1-Proposed Zoning Amendment

## **RESOLUTION 2018-31**

### **CONCERNING AN APPLICATION FOR A ZONING MAP AMENDMENT TO REZONE 5615 LYTLE RD. (40.7003 AC) AND SPLIT ZONING 5621 LYTLE RD. (THE REAR 1.29 ACS) FROM R-1 TO VT-PUD**

This letter is in regard to the Federle PUD Stage 1 planned in Wayne Township.

*Figure 7-1  
Required Sidewalk*

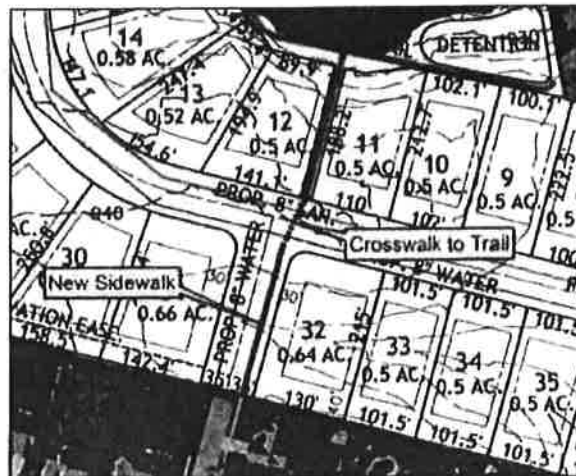
1. Recommend approval contingent on RPC recommendations (attachment A) being satisfied in addition to the following added conditions:
2. Increase side yard setback to the north of the development to a minimum of 25'; and,
3. \*(modification of RPC's §7.5 Sidewalk connectivity) Extend sidewalk or bike path from the east side of White Rose Dr. along the south side of main drive out to Lytle Rd. for pedestrian and central mail location traffic.
4. Adding language to the HOA regulations preserving the established wood lines 25' in width around the perimeter of the development.
5. All approvals are contingent on adequate sewer serviceability. And;

The existing sidewalk located on the east side of the White Rose Drive stub shall be required to be extended to the next intersection and connect with the proposed trail as shown in Figure 7-1 at right.
